LAKE TAHOE COMMUNITY COLLEGE
Student Housing Building Project
RFP #22-23-002
Addendum #1

PROJECT: RFP #22-23-002 – Student Housing Building Project

DATE: June 22, 2023

Description(s): Revised Increment 1 Drawings to show:

M4.1-2

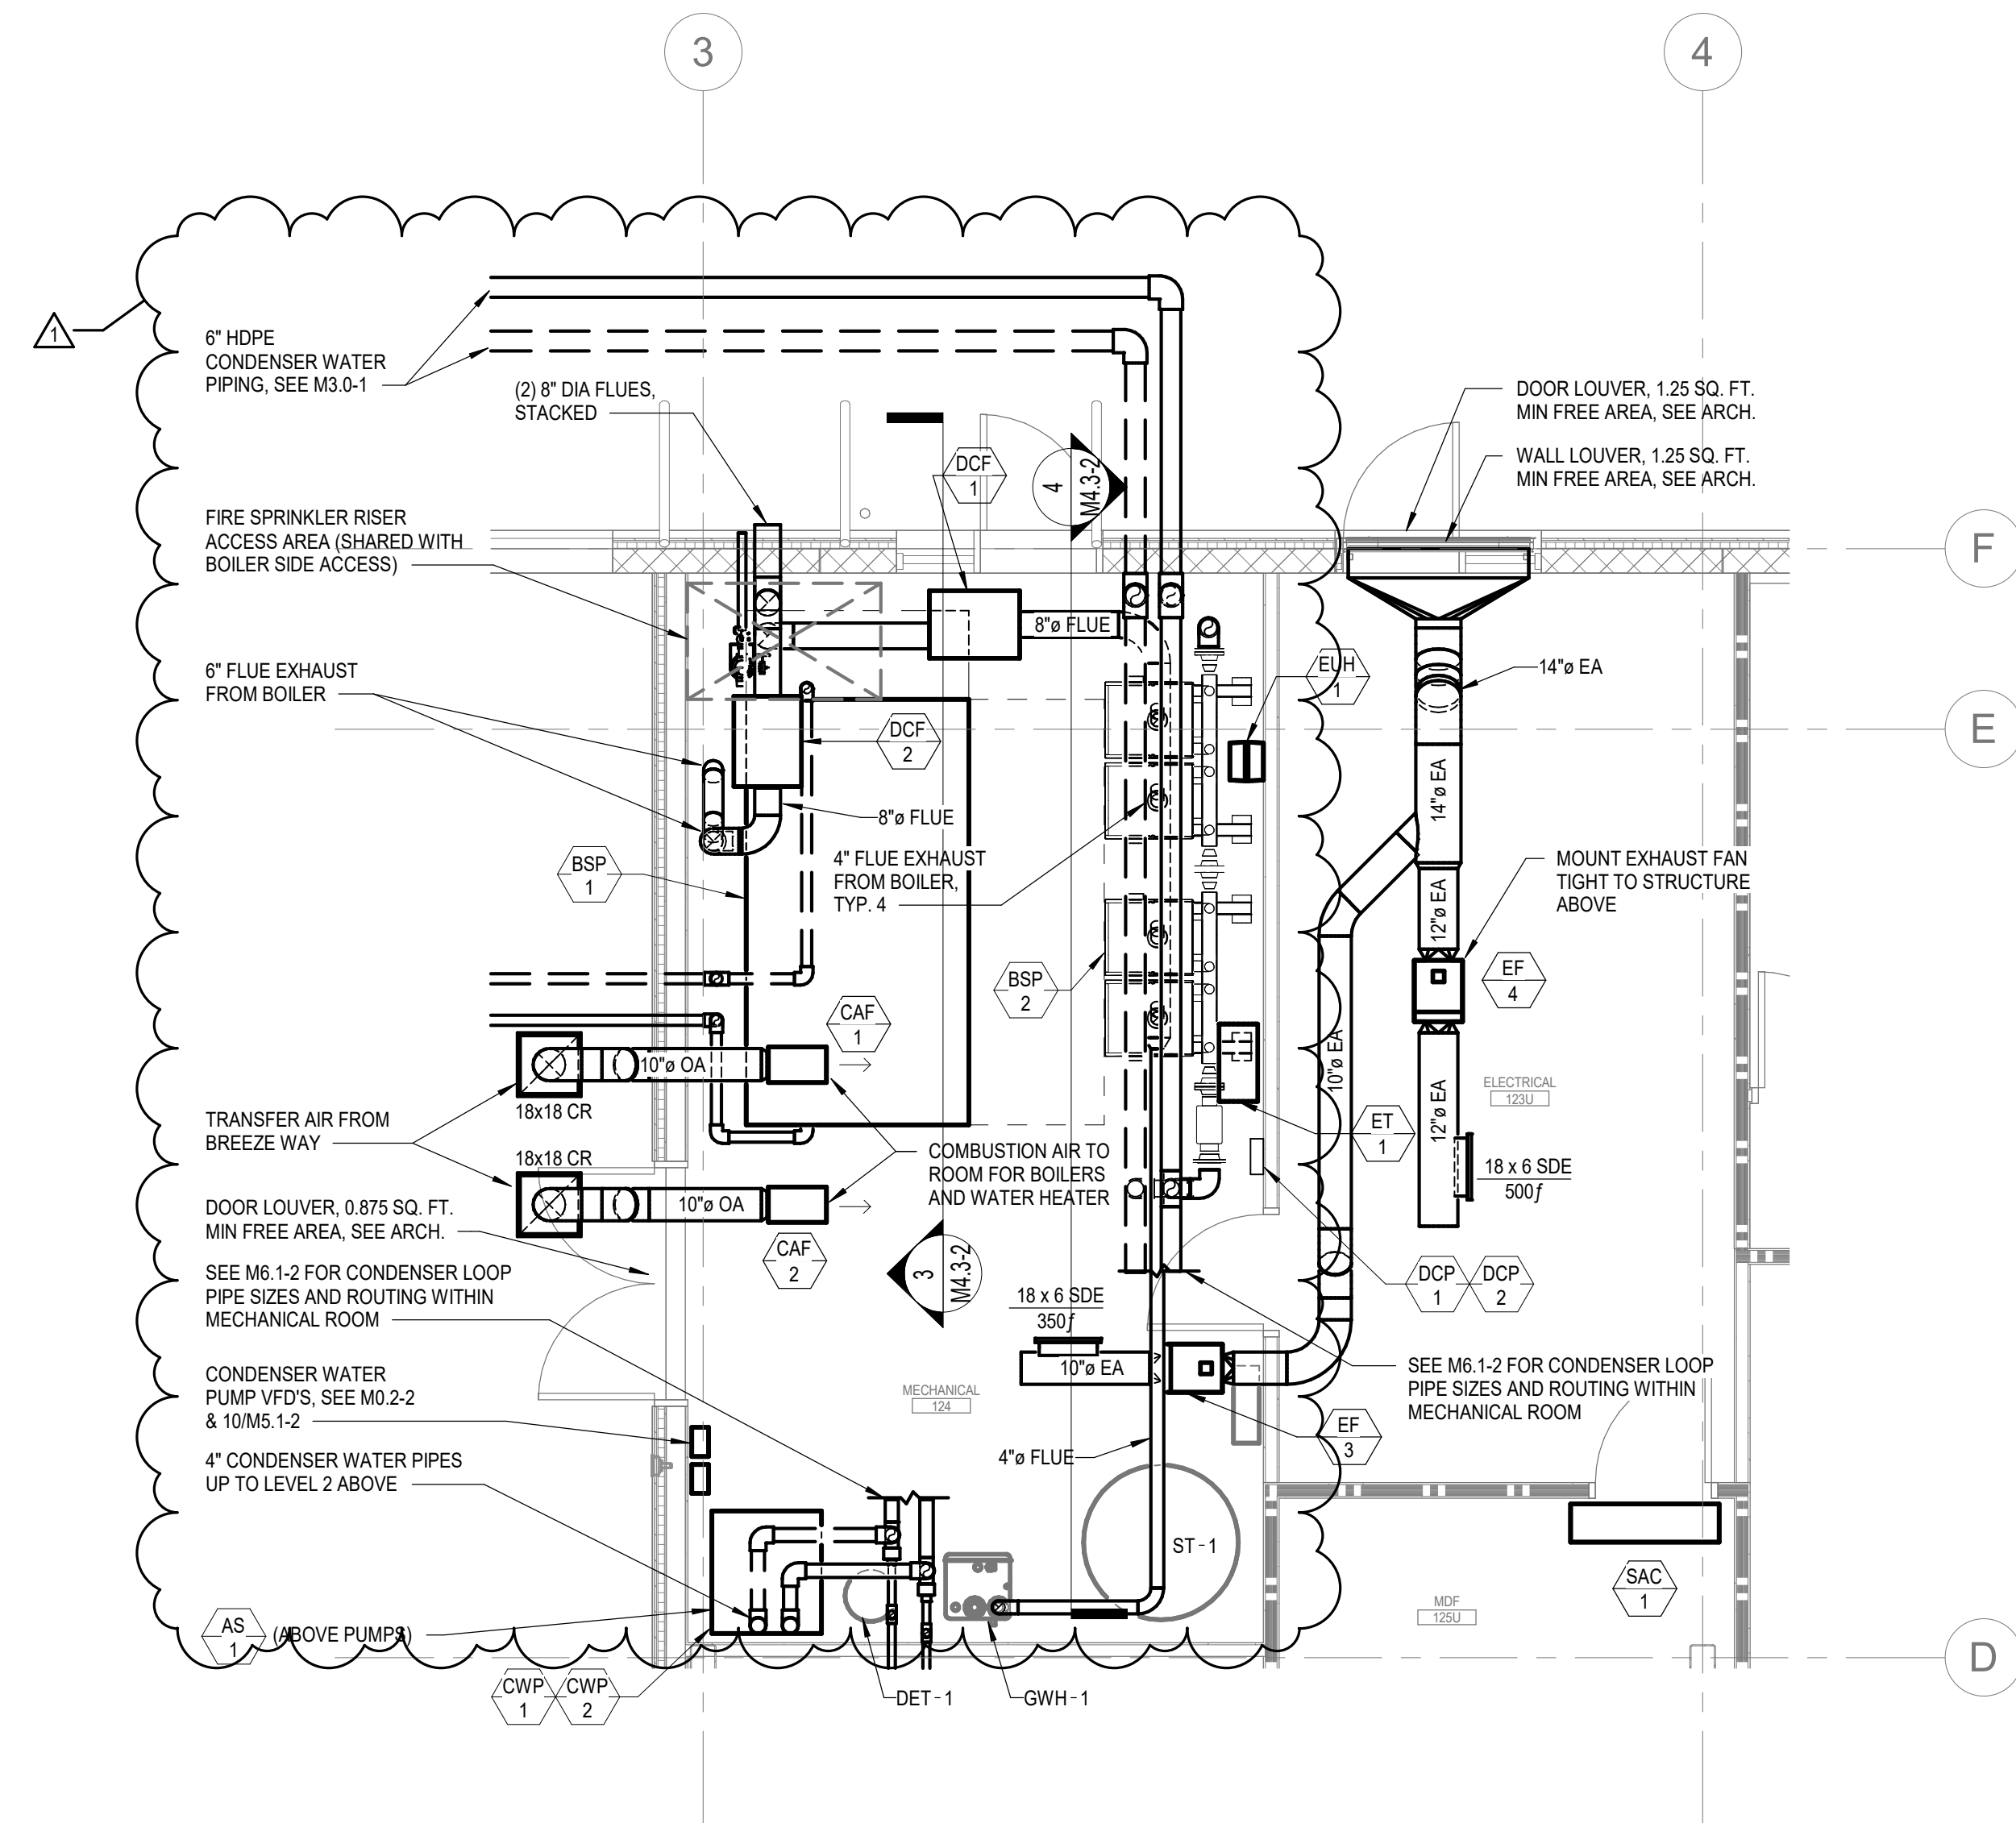
- Separation of snow melt boiler system venting from the heating hot water and water heater system venting.
- Draft control fan, combustion air fan, control panel, and accessories added.
